Addendum #1	County	Adams
	Local Public Agency	Quincy
September 7, 2016	Project Number	MR 599B
	2016 Capital Roadway Improvements – Wards 4 and 7

2016 Capital Roadway Improvements – Wards 4 and 7

This addendum forms a part of the bidding and contract documents and modifies the original bidding documents dated September 1, 2016. Summary of changes:

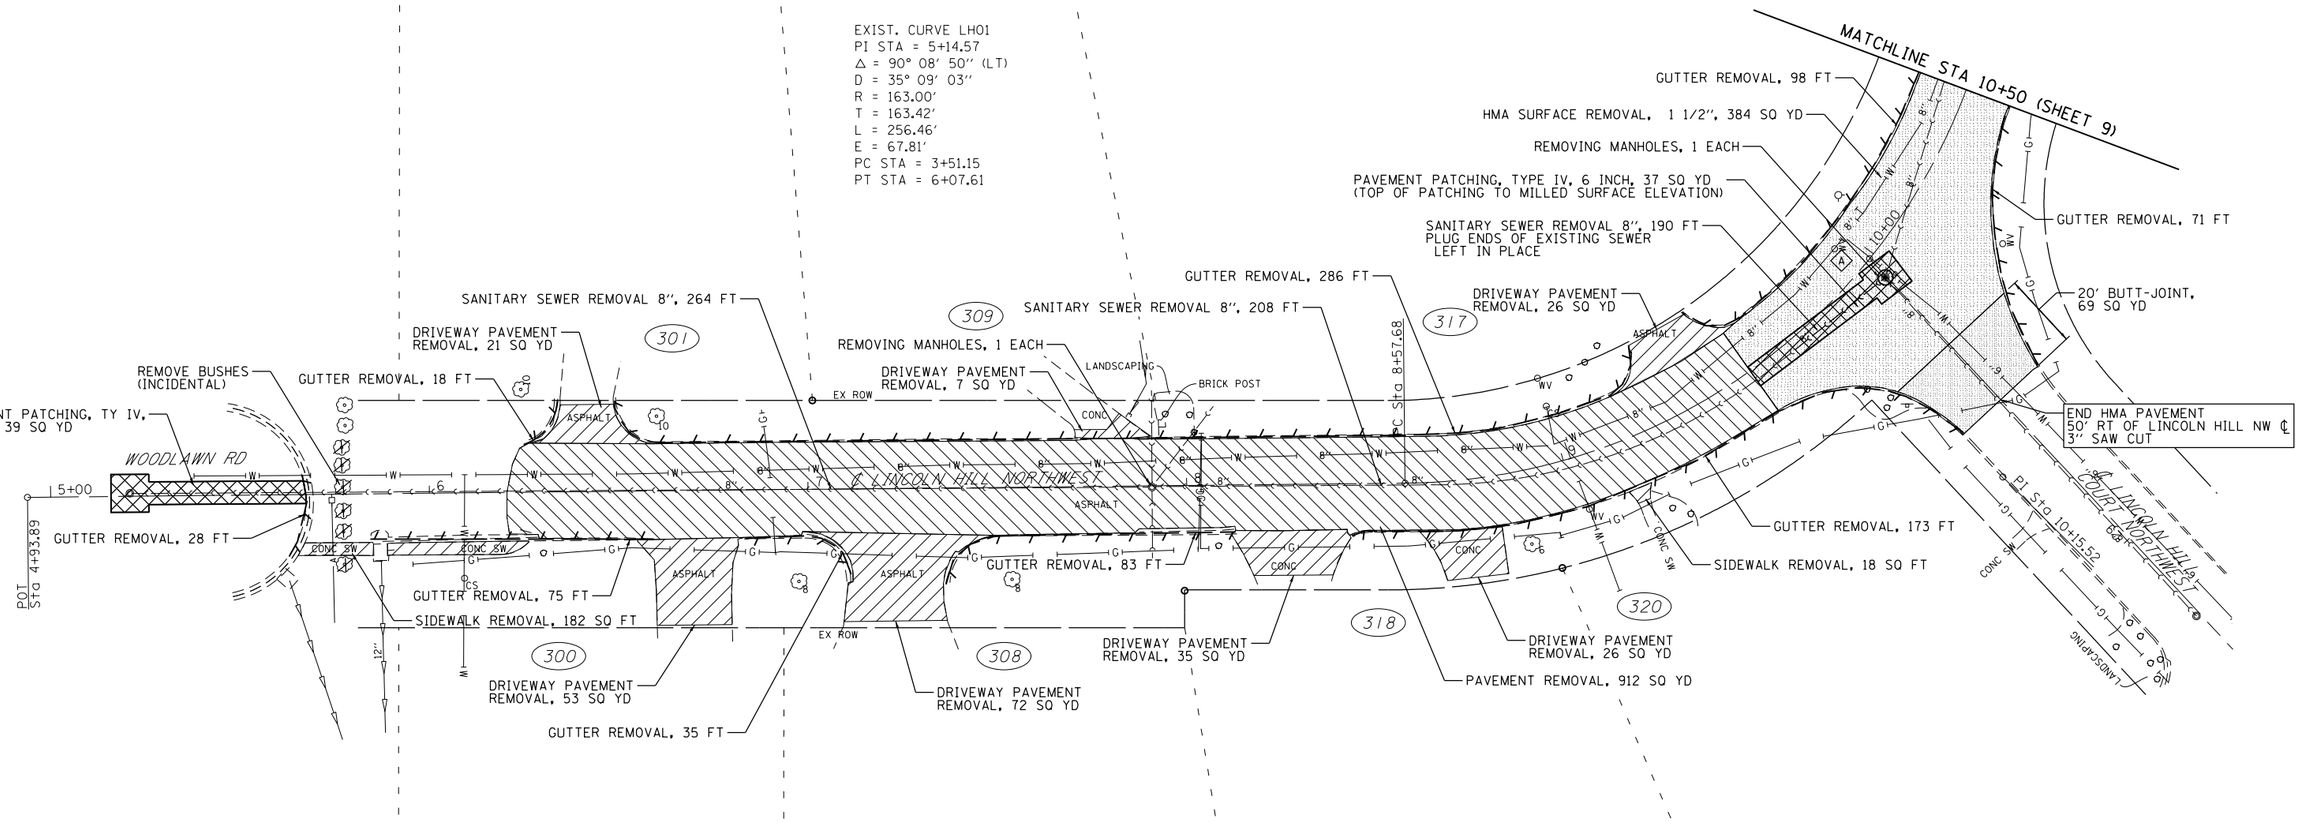
3. **SHEET 8 of 44** - Seperated the adjustment of valve boxes and curb boxes into individual pay items.

CURB BOXES TO BE ADJUSTED, 12 EACH
VALVE BOXES TO BE ADJUSTED, 2 EACH
(ESTIMATED QUANTITY - FIELD LOCATE RESIDENTIAL CURB BOXES).
SEE SPECIAL PROVISIONS FOR THE CITY OF QUINCY'S WATER SERVICE LOCATION DATA.

NOTES: THE MODIFIED CONCRETE GUTTER SECTION AND APRON SHALL BE MEASURED FOR PAYMENT AND PAID AS "CONCRETE GUTTER, TYPE V-12.12".

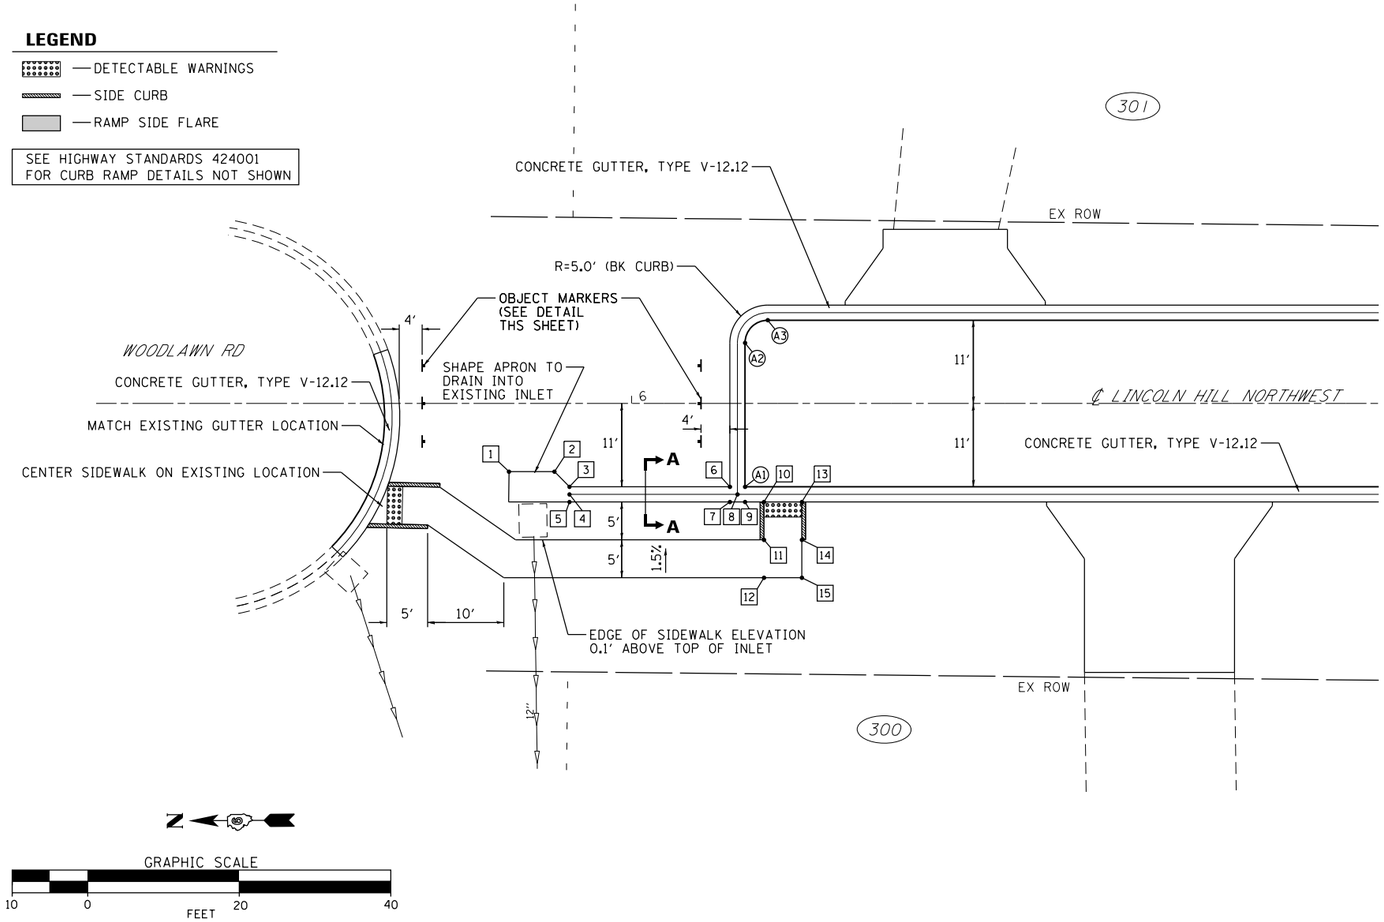
2. **SHEET 5 of 44** - Modified detail for the concrete gutter.

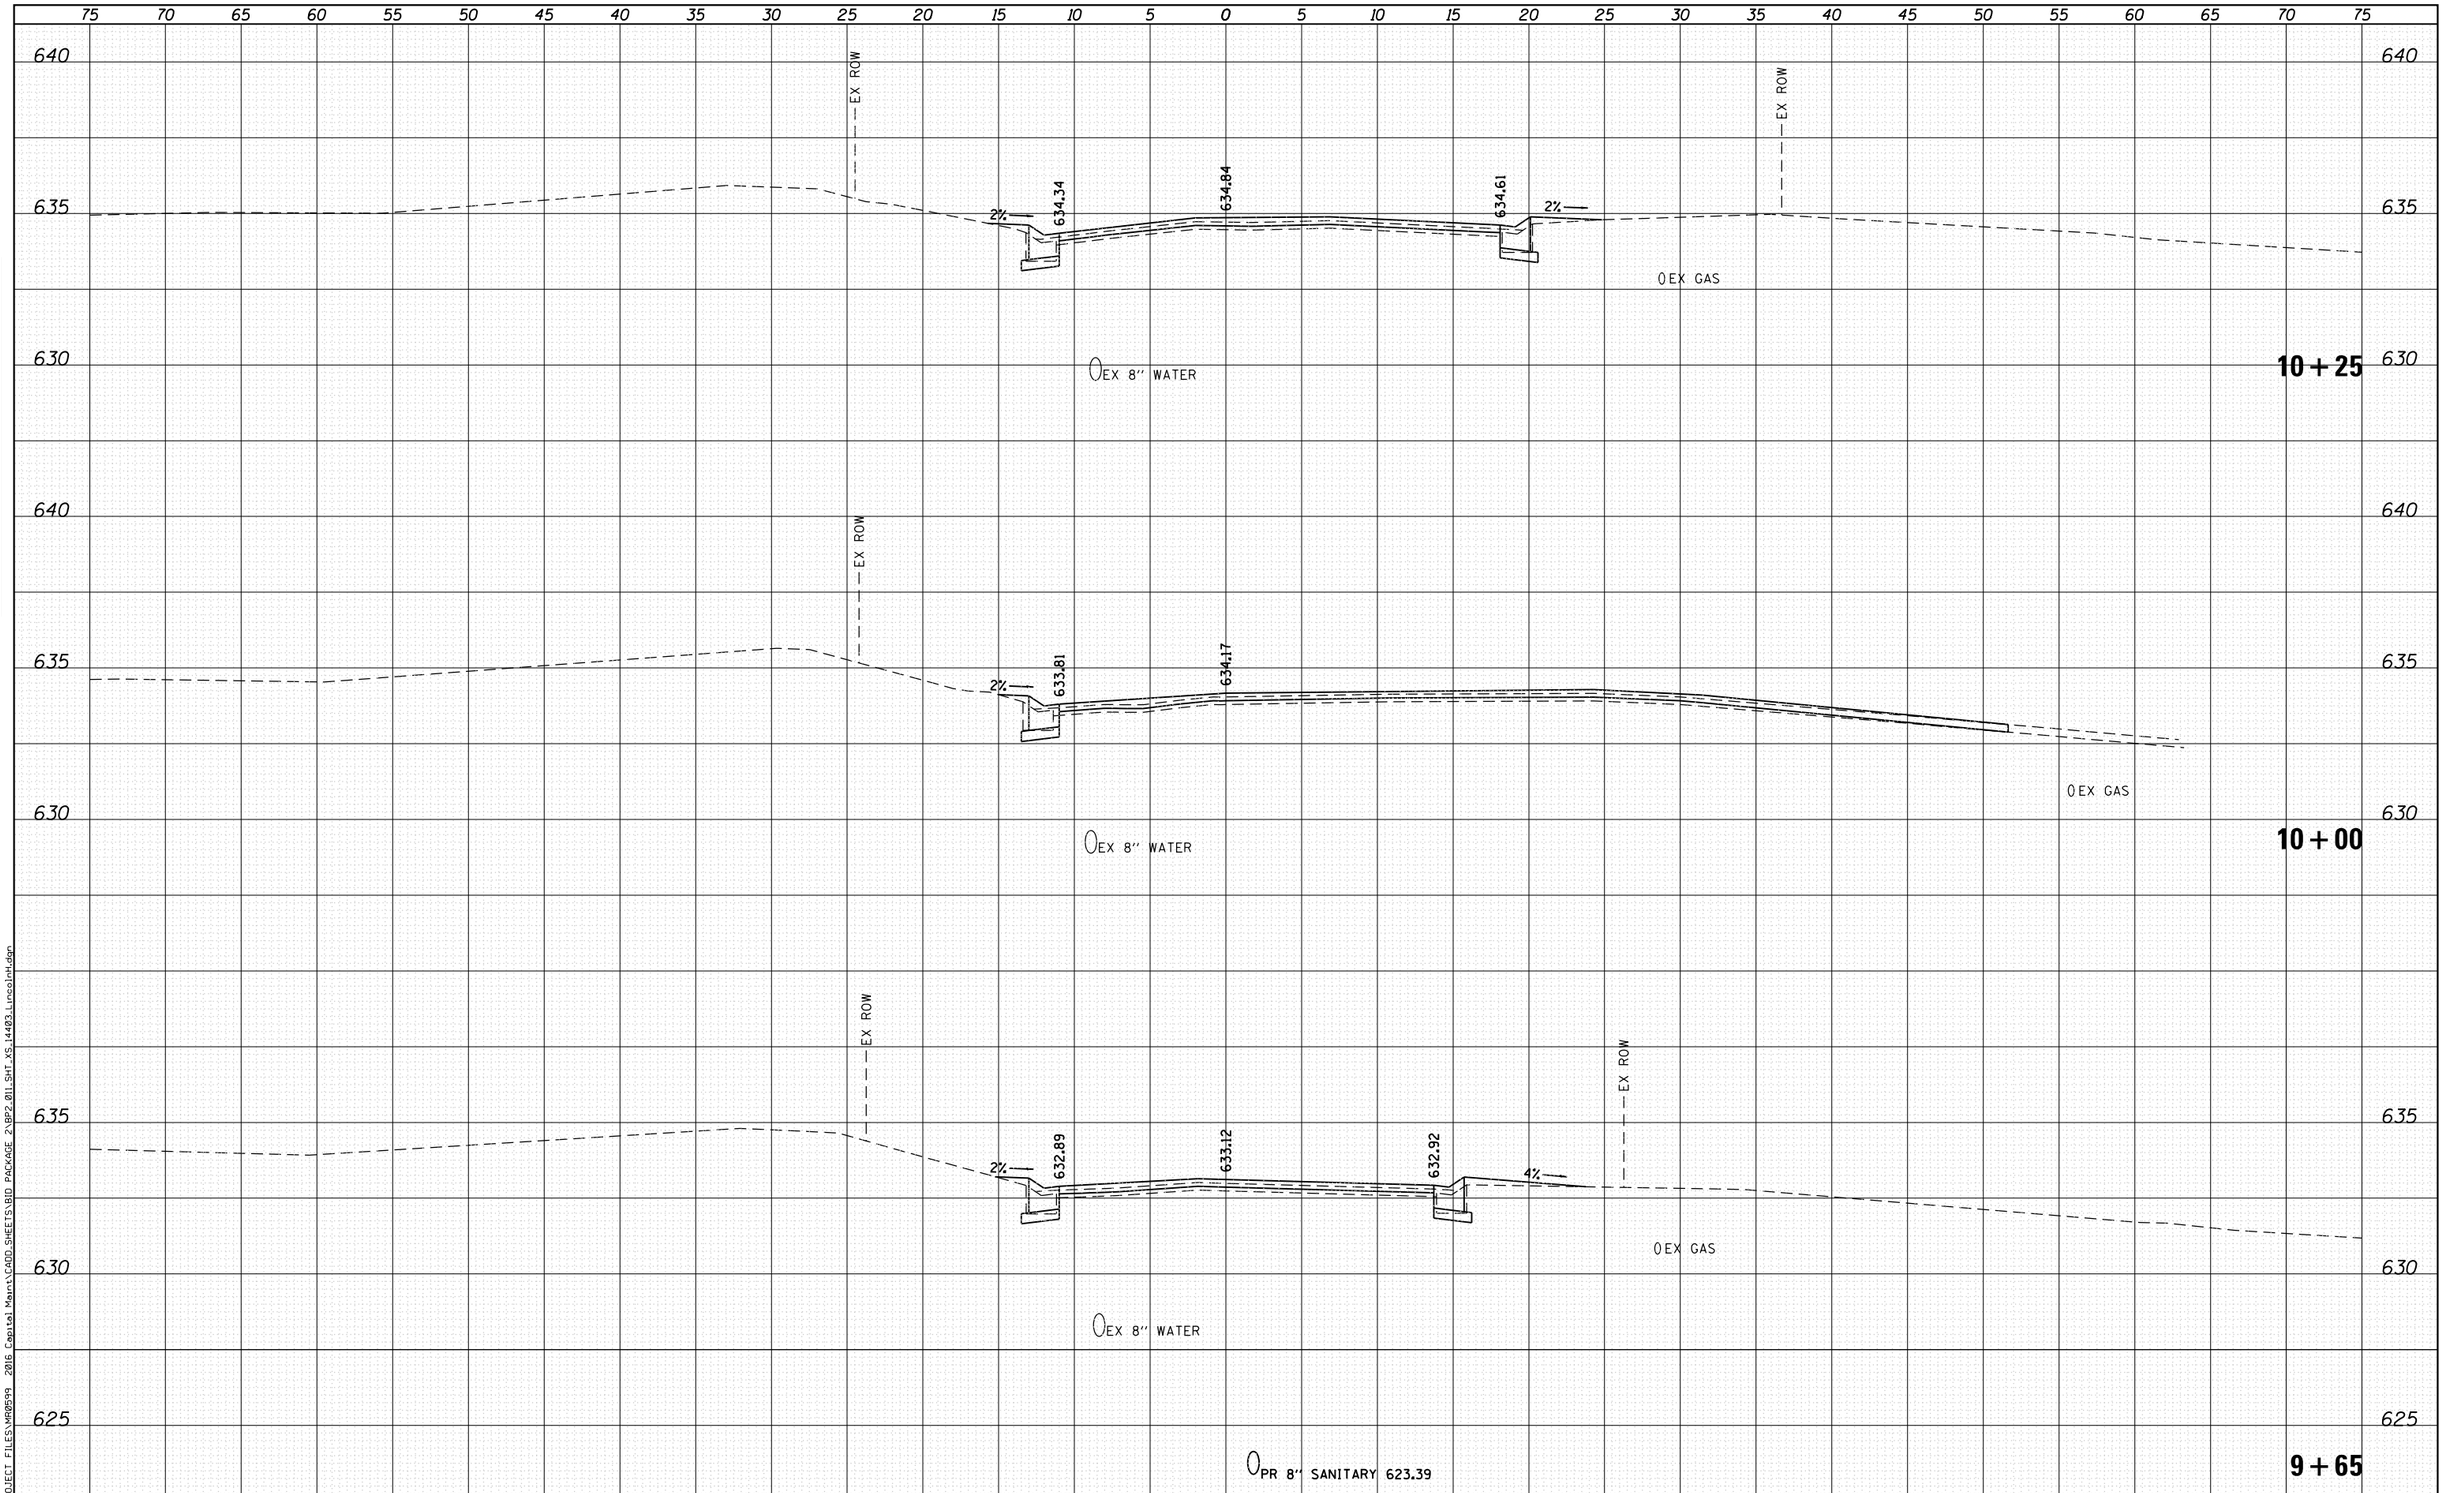
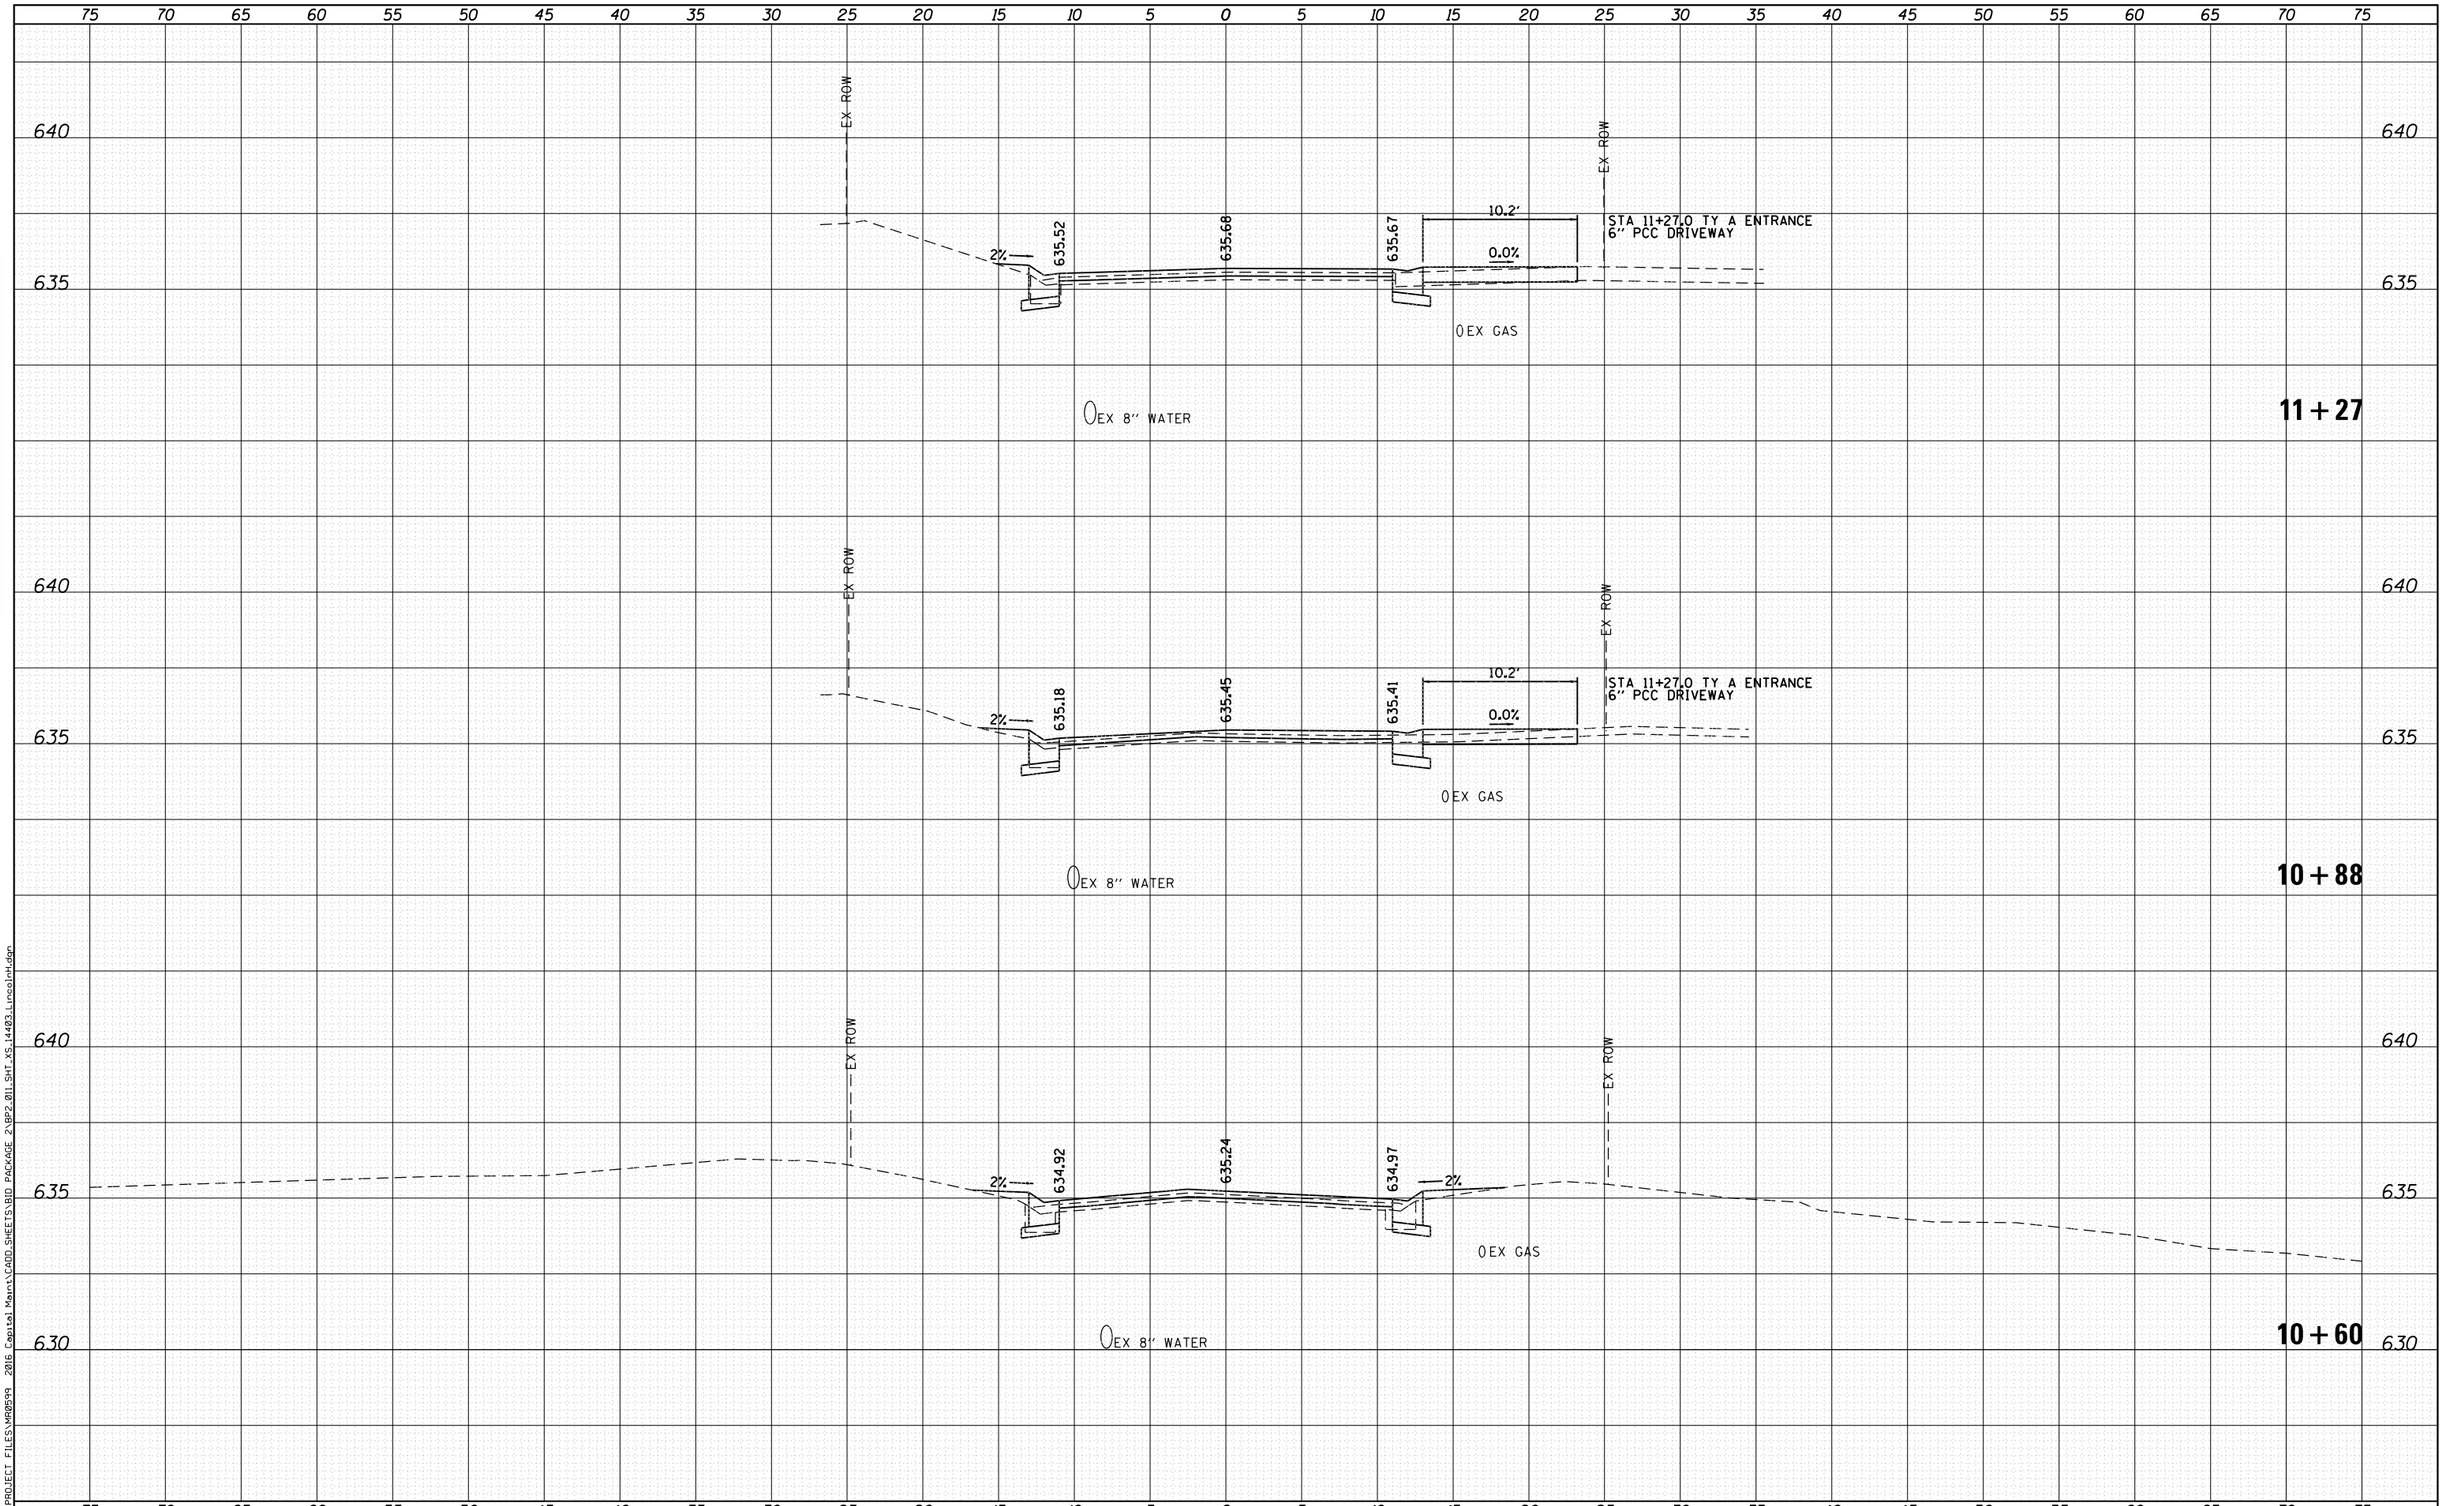
5. **SHEETS 17-23 of 44** - Added elevation labels for the edge of pavement.
